## SCH56xx Silicon Errata and Data Sheet Clarification

**FIGURE 1: INPUT CLOCK TIMING**

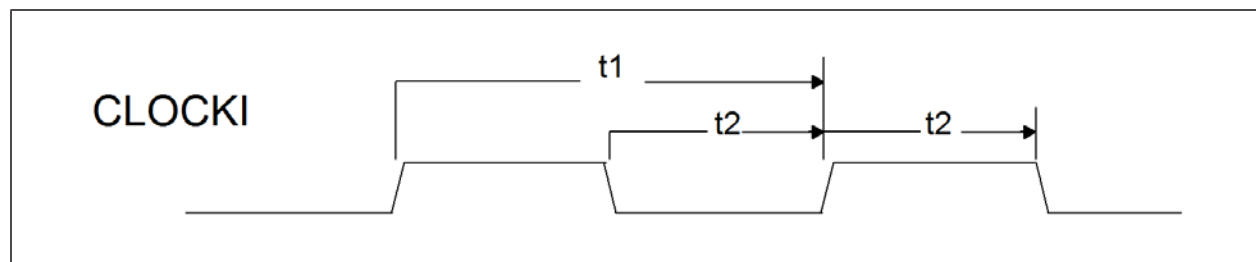
The following timing specifications will be added to the data sheet:

**TABLE 5: INPUT CLOCK TIMING PARAMETERS**

NAME	DESCRIPTION	MIN	TYP	MAX	UNITS
t1	Clock Cycle Time for 14.318MHZ		69.84		ns
t2	Clock High Time/Low Time for 14.318MHz	20	35		ns
	Clock Rise Time/Fall Time (not shown)			5	ns
